Agenda
Lane Cove Local Planning Panel Meeting
2 June 2026

Lane Cove Local Planning Panel Meeting 02 June 2026
21 - 25 AUSTIN STREET, LANE COVE

Item No: LPP9/26
Subject: 21 - 25 Austin Street, Lane Cove
Record No: DA25/153-01 - 36293/26
Division: Planning and Sustainability Division
Author(s): Andrew Bland

Figure 12: Massing plan (Source: Applicant)

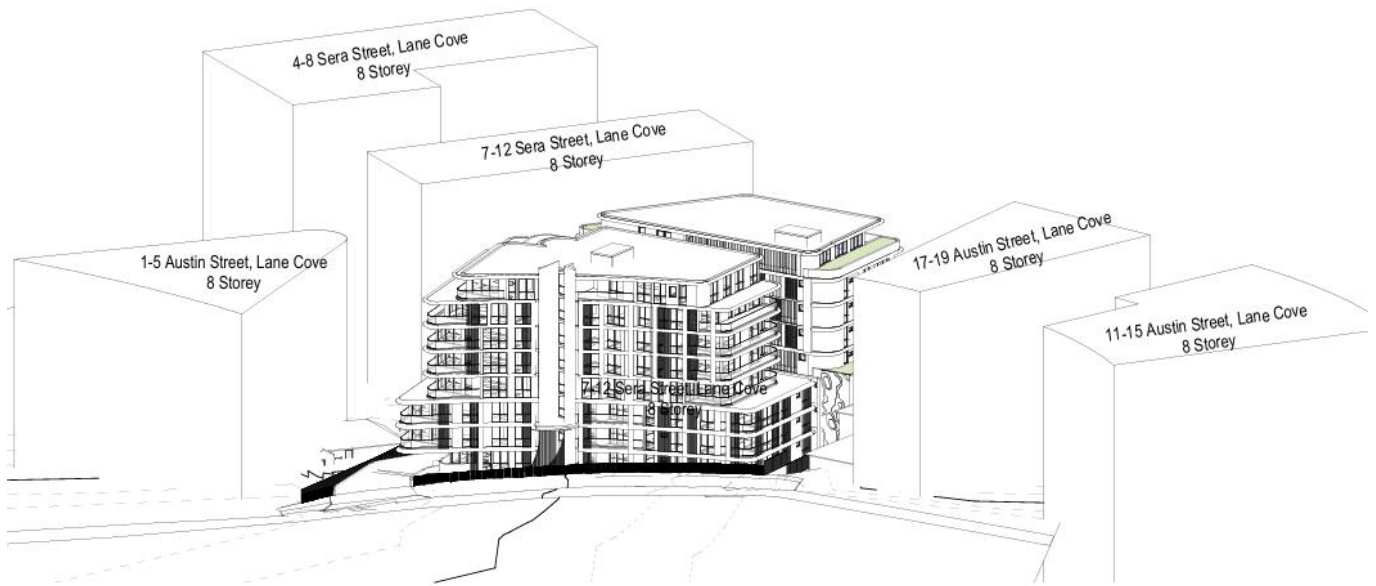
The massing plan in **Figure 12** above inaccurately represents the proposed 10 storey development as appearing smaller than neighbouring 8 storey developments. The neighbouring developments appear substantially larger than the achievable height, FSR and setbacks permitted under the Housing SEPP. The massing options fail to take into consideration the natural slope of the area. This plan fails to accurately depict natural ground level and has not provided any confirmed RLs to situate these buildings accurately.

Figure 13: Limited Active Communal Open Space highlighted in yellow. (Source: Architectural plans)

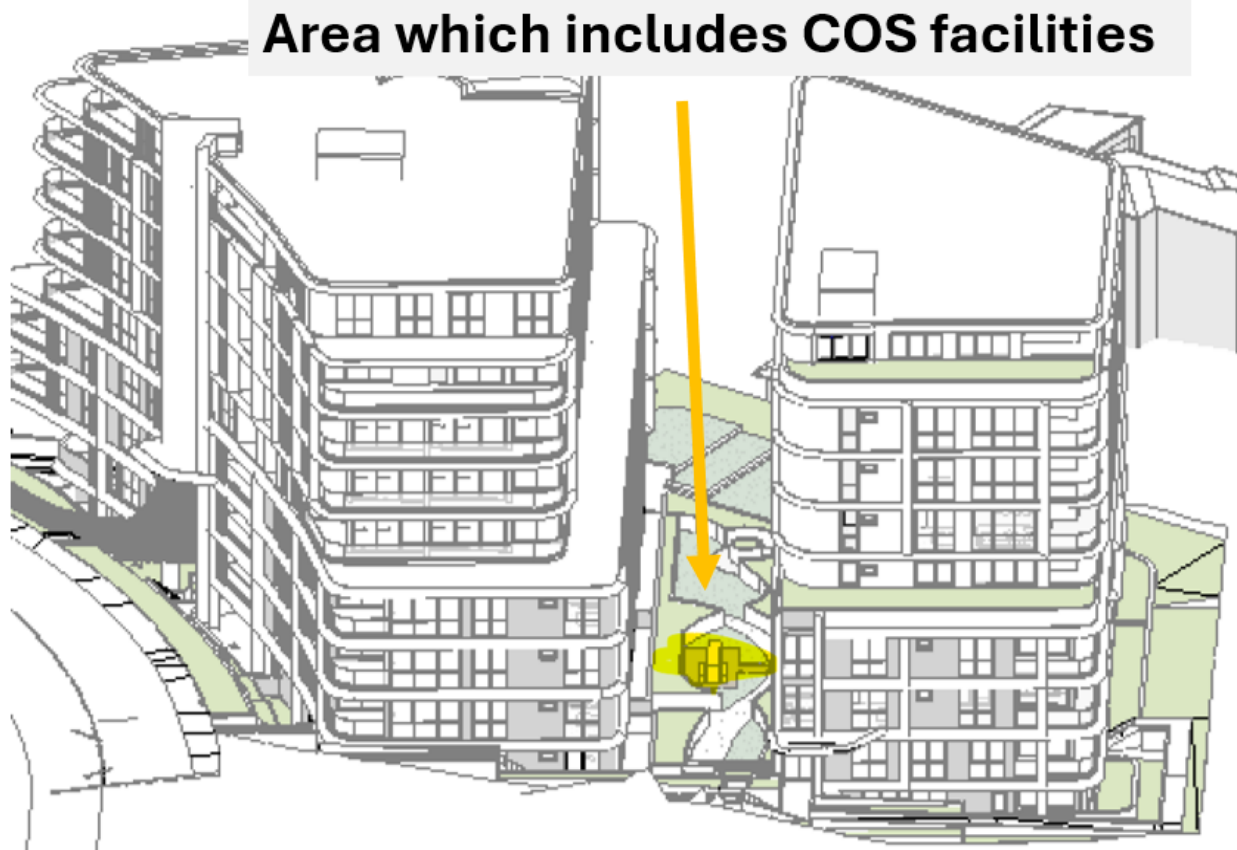
Council does not support the proposed COS as it would provide limited amenity and fails to satisfy the relevant requirements of the ADG and Council's DCP. The area denoted as COS on the architectural plans is predominantly occupied by pathways and areas of passive landscaping located between boundary setbacks. The proposal includes 238sqm of communal open space provided between Tower A and Tower B {central COS}, where 920sqm is depicted as COS on the Architectural plans. The provided total includes landscaped areas within setbacks, which would

provide limited usable amenities for the future residents. These setback areas are more appropriately categorised as deep soil / landscaped areas. There are no facilities which would encourage residential use or social interaction as sought by the ADG.

Figure 15: The blue area identifies the gallery areas which are incorrectly identified as non-habitable. (Source: Architectural Plans)

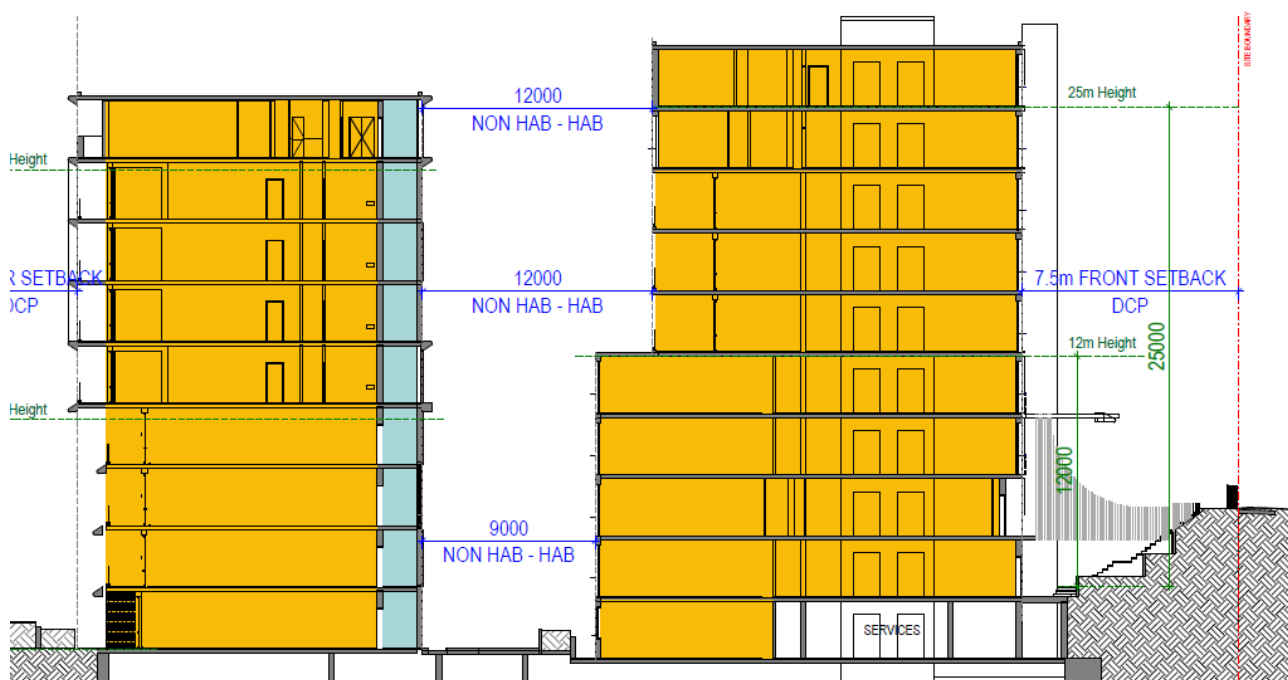
The Applicant has considered the gallery areas shown in blue as non-habitable, refer to **Figure 15** below:

The proposed development fails to satisfy the ADG separation requirements as shown in **Table 12** below:

The internal separation between Tower A and Tower B does not comply with the objectives of the ADG requirements. This is not supported due to the significant impacts on amenity resulting from the design response to the limited separation. The treatment of the walls results in poor visual amenity for the units which face the façade of Tower A, particularly the single aspect units.

Figure 16: Tower A Austin Street Frontage (Source: Updated Architectural Diagrams – DA9036)

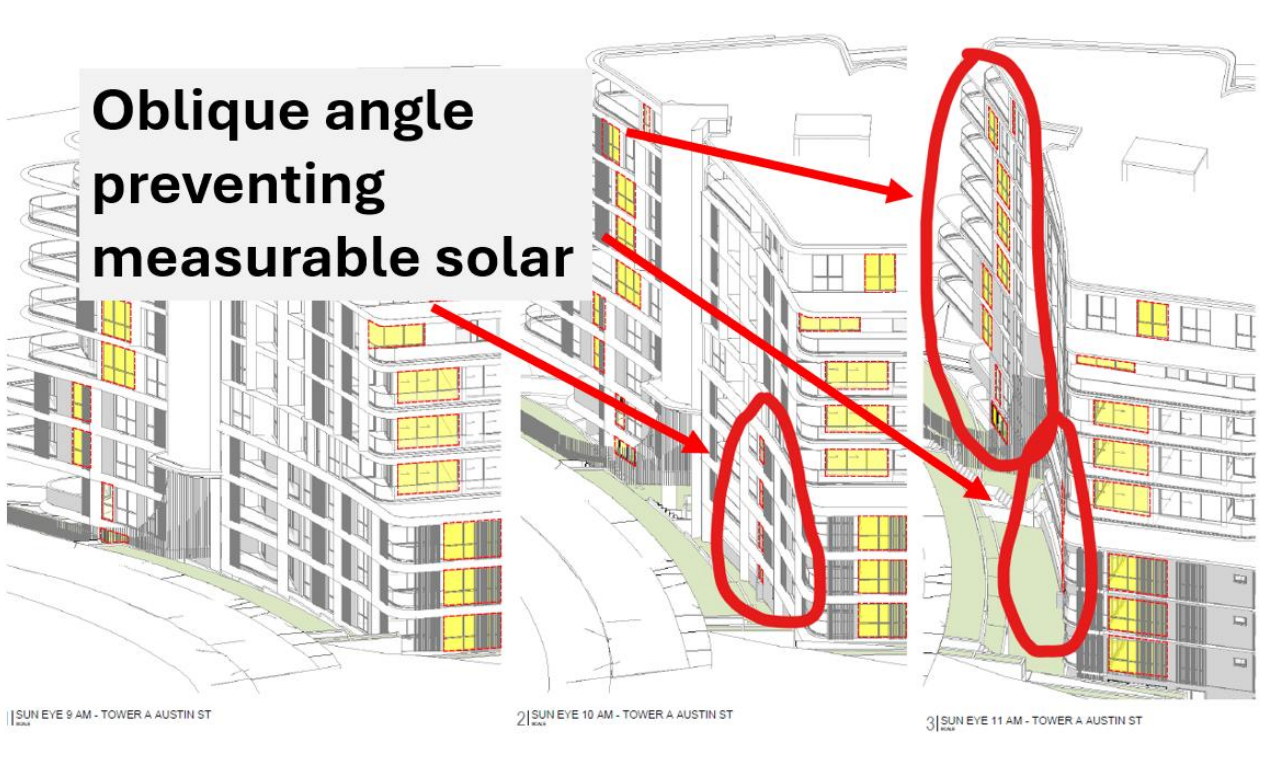
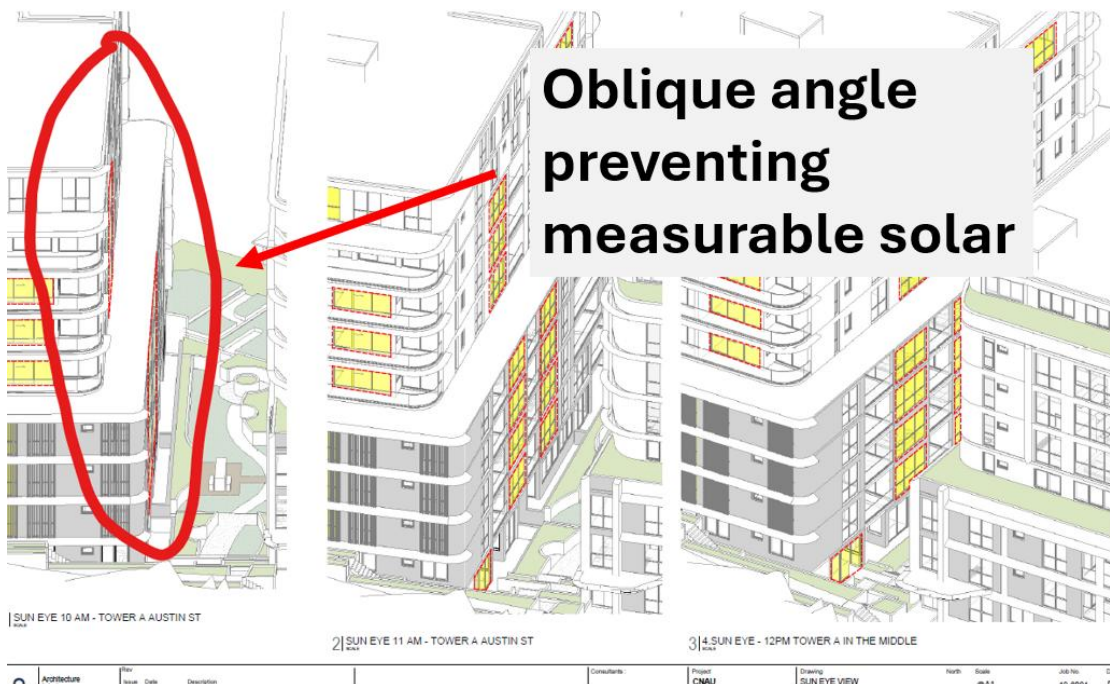
Compliance is reported however the updated sun-eye diagrams do not demonstrate that measurable / substantive solar access has been provided to the subject living rooms. The elevations identified in **Figure 16** and **17** rely on oblique angles of sun light which are unlikely to provide meaningful penetration of direct sunlight to living spaces.

A clarification was sought in regard to Apartment A-101 (amongst others) to confirm whether compliant solar access was provided to the living room. The updated sun-eye diagram does not demonstrate compliance given the oblique angle.

Figure 17A: Screening for balconies indicated in red (Source: Updated Architectural Plans – DA 9109)

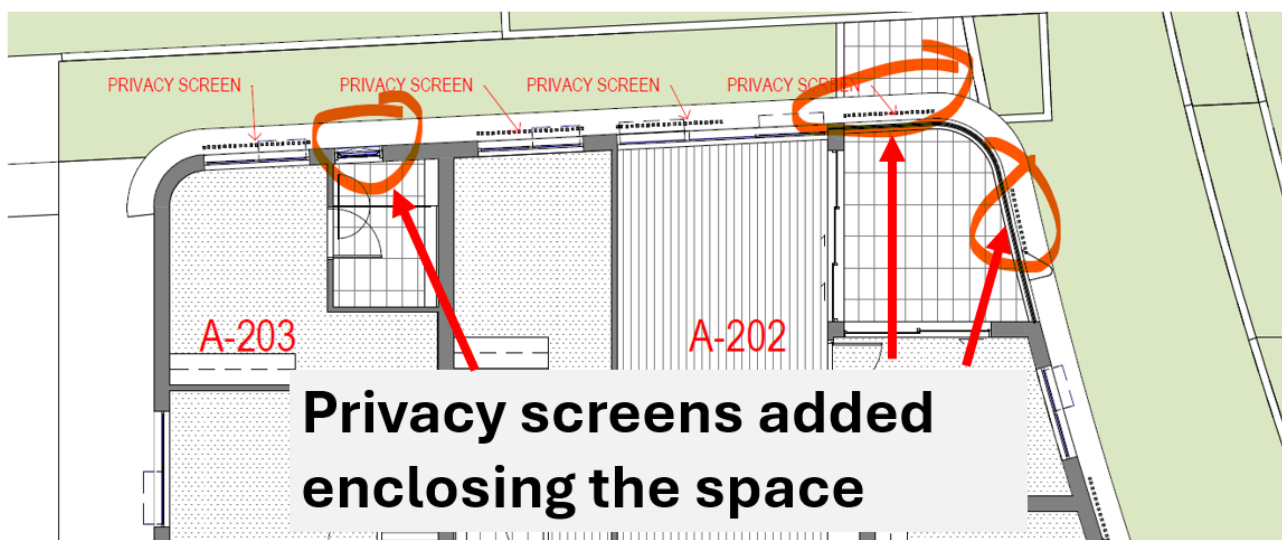
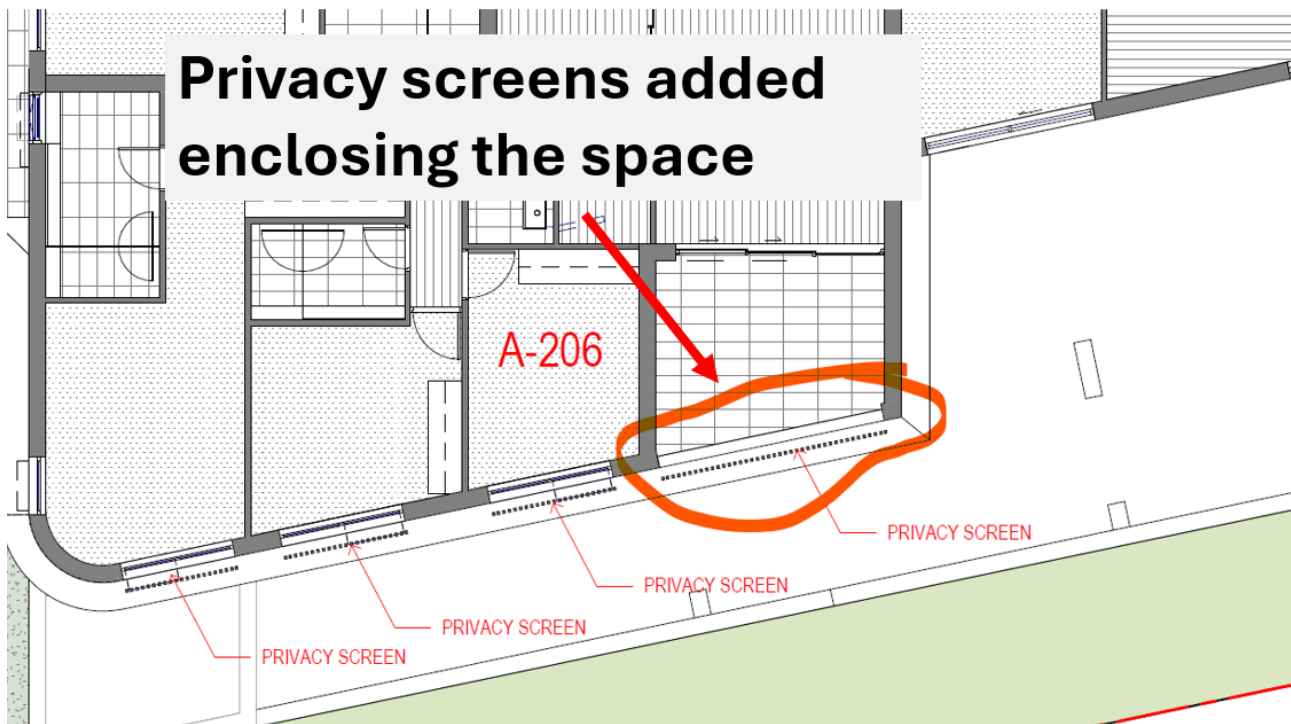
The extensive screening provided would result in an unacceptable amenity outcome for units such as A-202, A-203 and A-206, refer to **Figure 17A and 18** below.

The Applicant has sought to address privacy concerns through the provision of privacy screens. These screens may potentially enclose balconies and could be used as rooms. Insufficient details have been provided to ensure that these areas aren’t considered as GFA. The units which relate to this concern include A-203, A-202 and A-206, as shown in Figure 17A and Figure 18 in the ADG assessment section of this report.

Figure 21: Front setback excavation shown in blue (Source: Architectural Plans)

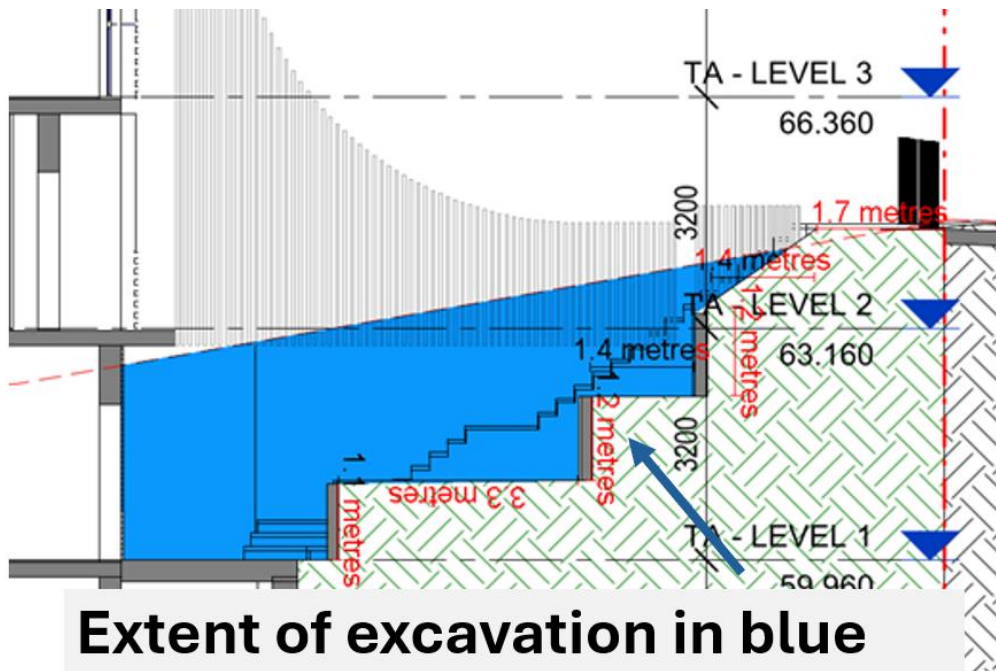
the streetscape and adjoining developments. The proposed excavation within front setback area would result in adverse amenity impacts as reported in the ADG assessment earlier in this report. This restricts both the active residential use and the passive use (landscape amenity benefits for the streetscape). The proposed development should be amended to achieve the desired approach (as influenced by the ADG and DCP) to the front setback areas along Austin Street for RFB developments. The proposed development contrastingly promotes a canyon like area which does not positively contribute to the amenity of subject residents or the streetscape, as detailed through the ADG assessment section of this report.

Figure 23: Clearance required for Council’s waste truck (Source: DCP)

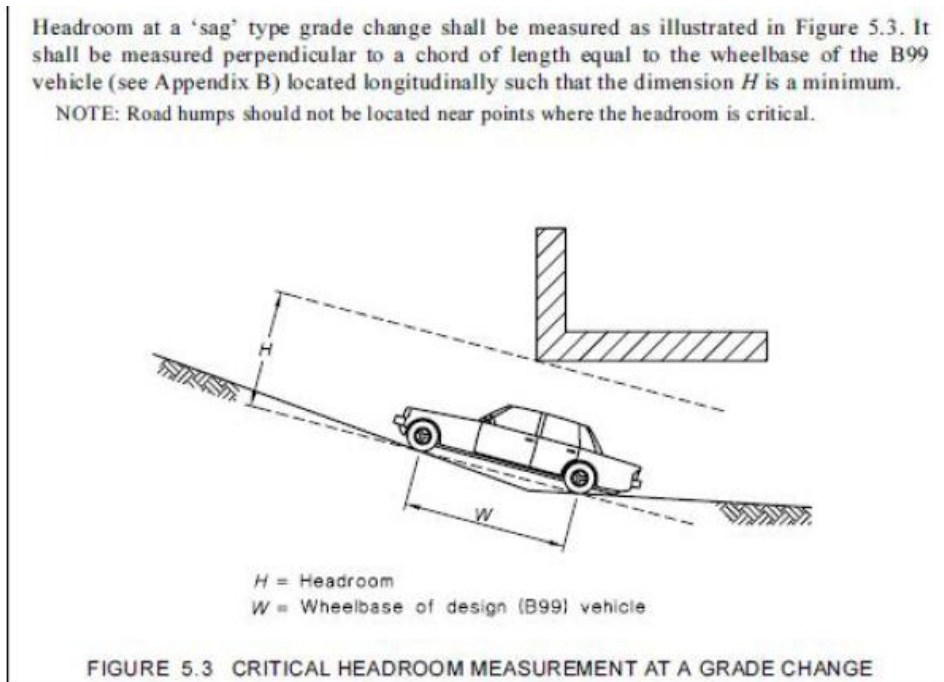
- c) As per Attachment 2 of TIA, the maximum clearance height provided in the basement is 2.5m which is insufficient for Council's Waste Vehicle's. The required clearance is 2.6m. The proposed basement fails to accommodate the maximum headroom measurement for the vehicle to enter as per AS/NZS 2890.1:2004 **Figure 23**.

Figure 24: Specifications required for Council’s bulky waste truck (Source: DCP)

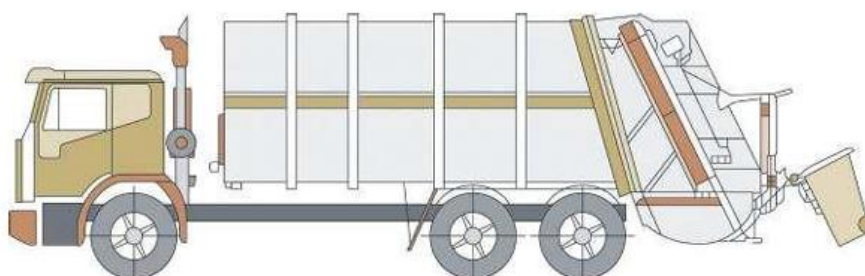
- d) The proposed development requests bulky waste collection from the Street. This is not supported by Council’s Traffic team as the site frontages is all on NO STOPPING areas. This would cause sight distance and traffic flow issues on Austin Street. Bulky waste collection is to be facilitated in the basement or on site.

- e) The bulky waste can’t be serviced from the street and thus must be accommodated on site. The clearance required for onsite Bulk Waste collection is 4.3m and must be accommodated in accordance with the “Typical Garbage Truck used for Domestic Waste Collection – Rear Load” detailed on page 25 of the Waste DCP. Refer to details in **Figure 24** below.

Figure 26: Incorrect calculations shown in dark blue (Source: Council’s Landscape Officer)

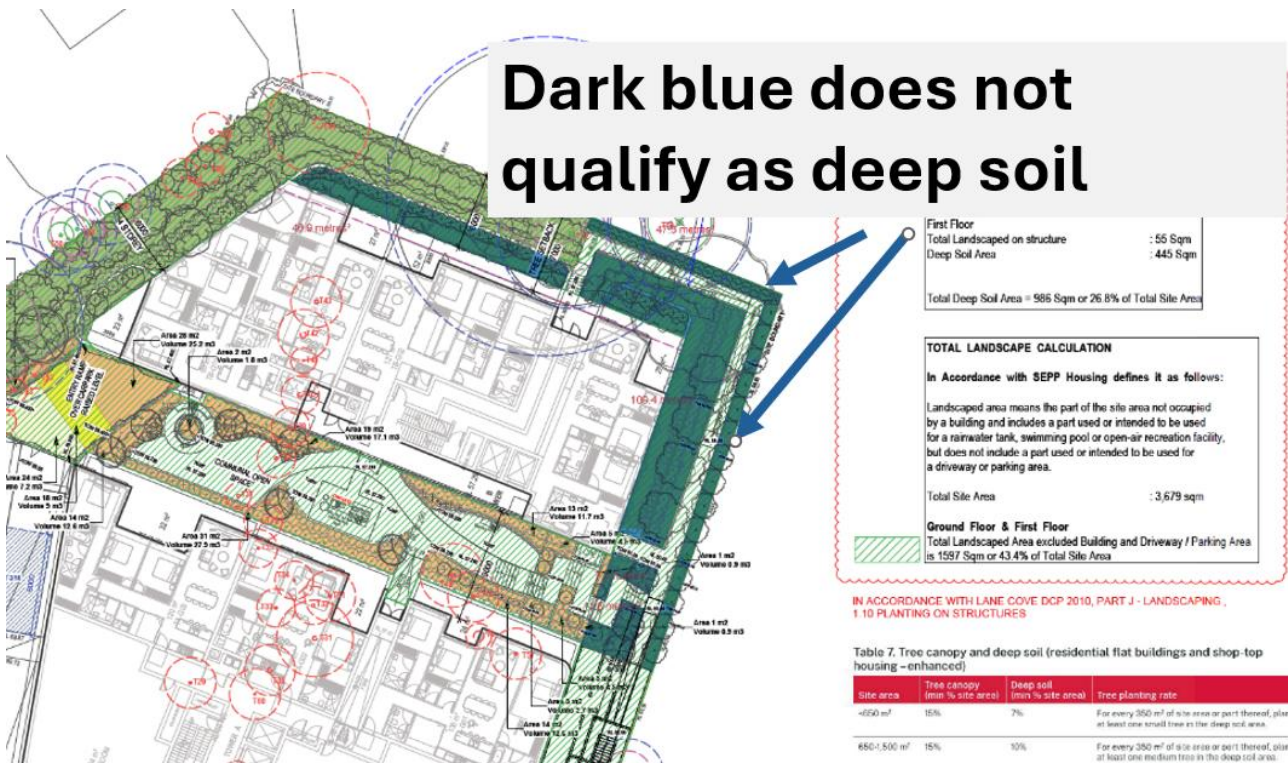
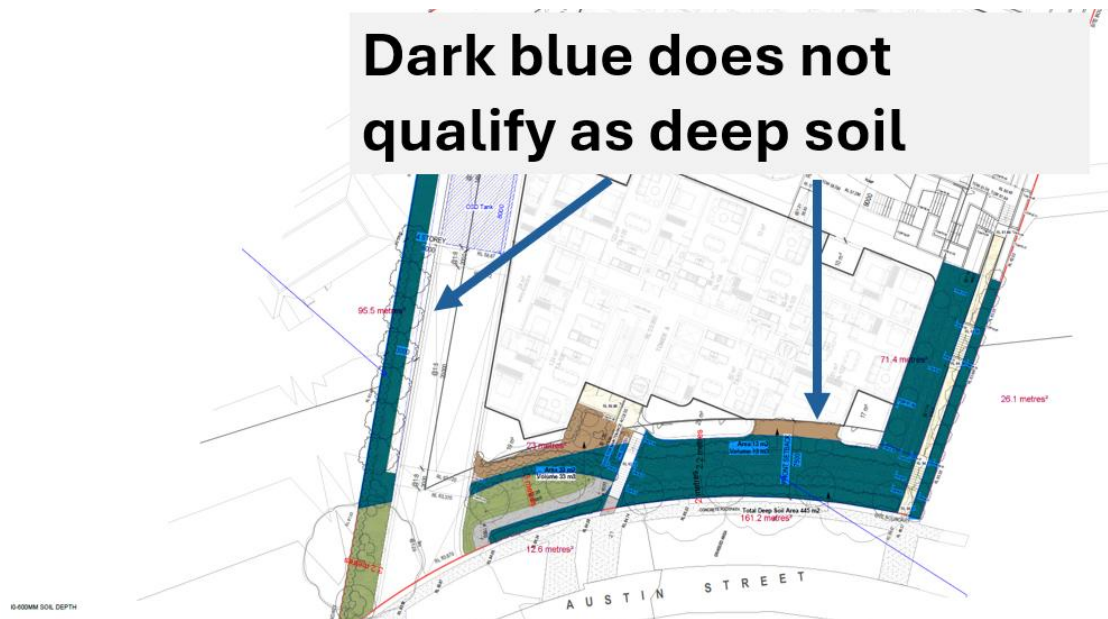
The deep soil calculations for the development area that accord with this definition have been assessed as 379.2m² / **10.3%** (min 3 x 3m). **Figure 26** and **Figure 27** below highlight in dark blue the areas that have been incorrectly included in the Deep soil calculations.

Figure 28: Building B - Northern Setback - +2.7m excavation, min 2 retaining walls + footings (Source: Council's Landscape Officer)

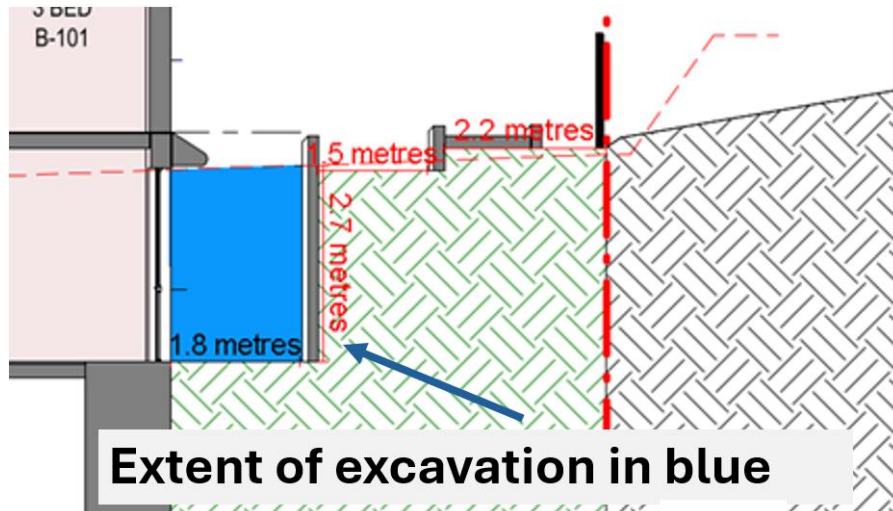
Extensive excavation proposed additionally removes the natural soil profile for a lot of area where deep soil has been claimed. This removes the soil profile capable of sustaining mature tree growth. Excavation to these levels should not be supported.

Detail sections of the proposal have been marked up showing the extent of excavation and retaining walls below:
